S E R V I C E N O T E

**OmniBER 37718 / 37719 Comms Performance Analyzer**

The following modification is recommended to eliminate potential overheating and premature failure of DS<sub>n</sub> DS1 Drop (Demux) Port driver.

Figure 1. Location of Components.

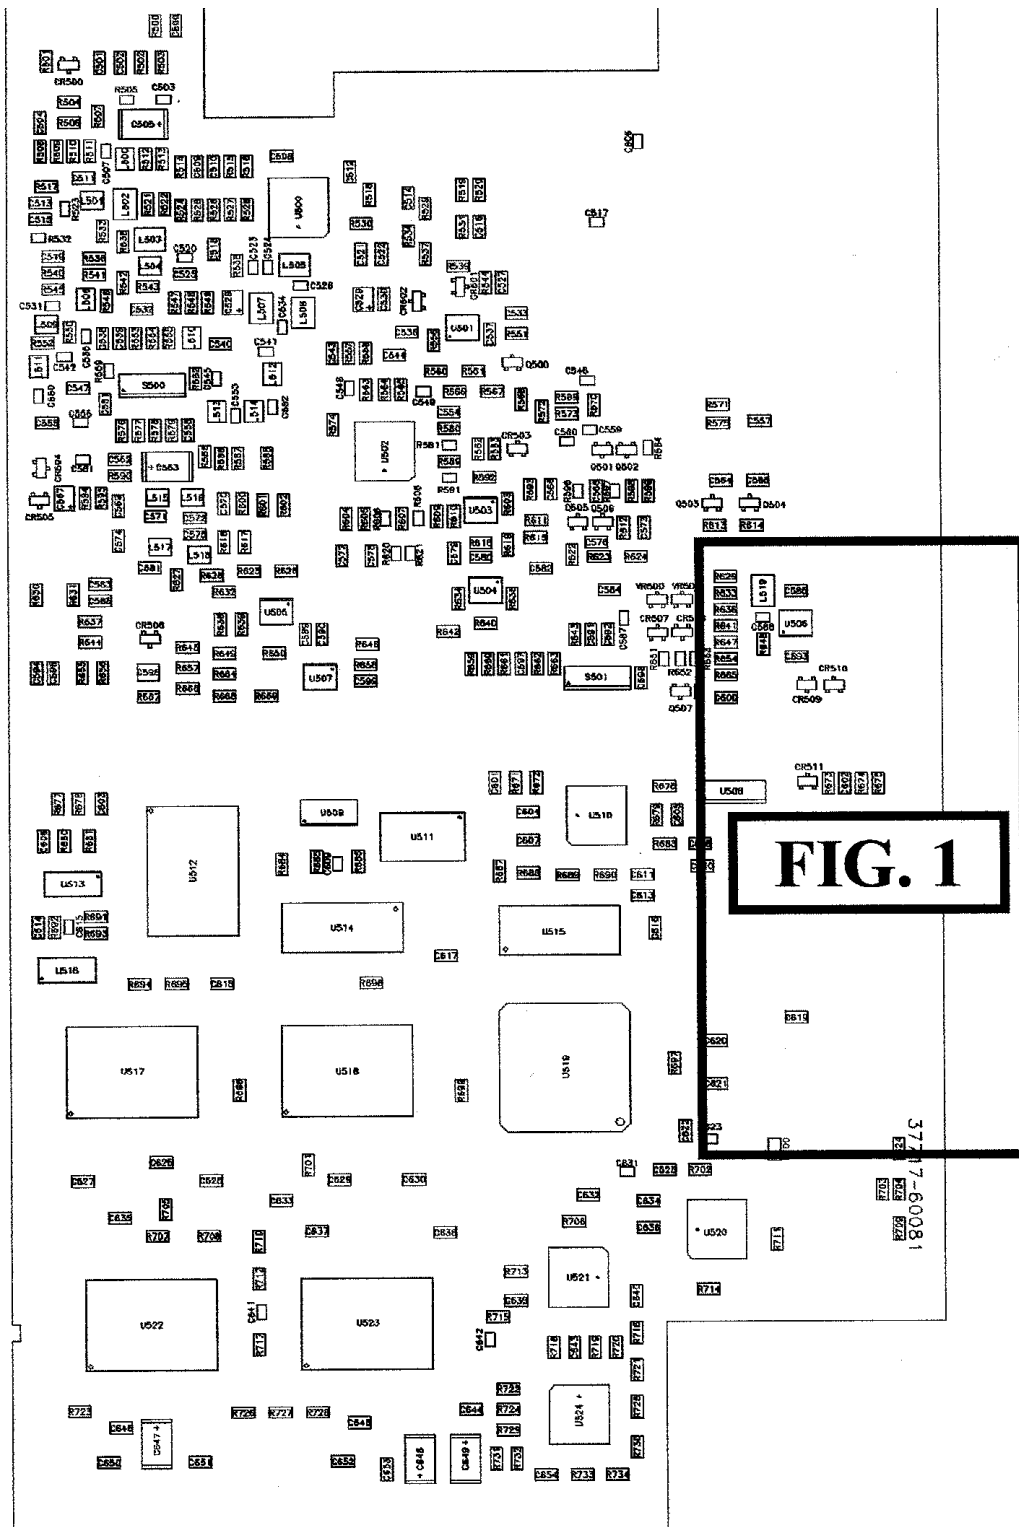
2. Note: Only perform this step if DSn Drop Port is defective. Remove/replace U505 (PN 1820-8942) taking note of orientation.
3. Solder a 10k ohm resistor Ra (0699-1391) to rh pin of TP8.
4. Solder a 10k ohm resistor Rb (0699-1391) to rh pin of TP8.
5. Add a wire link from vacant end of Ra to U506 pin 1 using insulated wire (see Figures 1 and 2).
6. Add a wire link from vacant end of Rb to U506 pin 7 using insulated wire (see Figures 1 and 2).
